**PLANNING DEPARTMENT ADMINISTRATIVE PUBLIC HEARING
SUMMIT COUNTY, UTAH
April 17, 2025**

Planning Department Staff Report

Subject: 569 Park Avenue
Application: PL-25-06457
Author: Meredith Covey, Planner I
Date: April 17, 2025
Type of Item: Administrative Conditional Use Permit

ARCHITECTURAL SITE PLAN

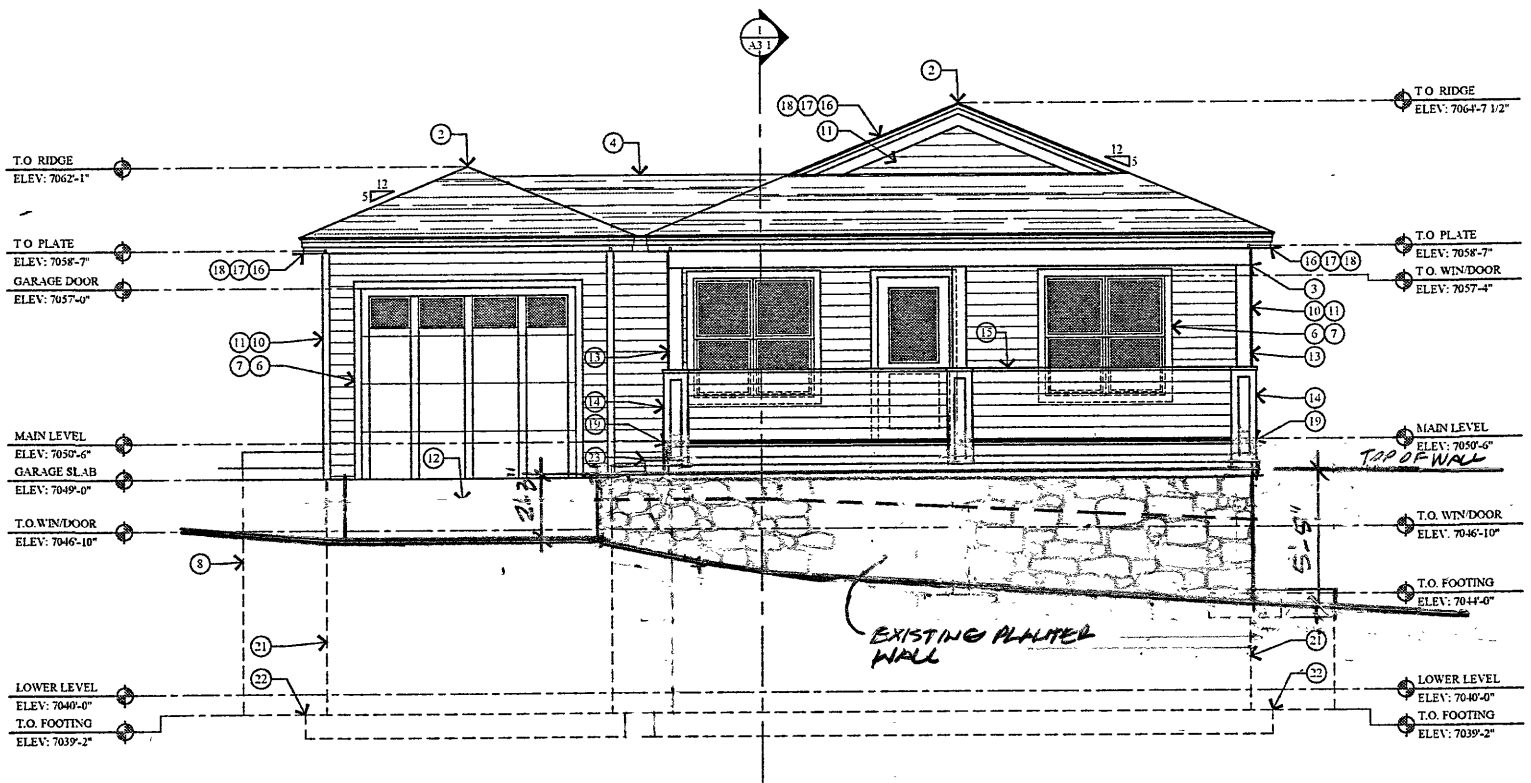
The Applicant proposes a retaining wall that exceeds four feet in height in the Front Setback. The wall ranges in height from 2 feet 3 inches at the southeast end of the wall to 5 feet five inches at the northeast end of the wall (Exhibit B – Proposed Plans).

11. The proposed height of 5 feet 5 inches does not represent a significant change relative to the existing retaining wall in this location.
12. The proposed wall is in the same location along the street. The increase in height from what was seen historically at the site helps to maintain the historic relationship between the bottom of the porch and the top of the wall. The stone masonry utilizes stones in the same style and dimensions as the historic retaining wall.

3. The Applicant shall install landscaping on top of the retaining wall to reflect previous conditions and minimize the visual impact of the retaining wall when viewed from Park Avenue.
4. The Applicant is responsible for notifying the Planning Department prior to making any changes to the approved retaining wall. Any changes, modifications, or deviations from the approved scope of work shall be submitted in writing for review in accordance with the applicable standards by the Planning Director or designee prior to construction.
5. Any changes, modifications, or deviations from the approved scope of work that have not been approved in advance by the Planning Department may result in a stop work order.
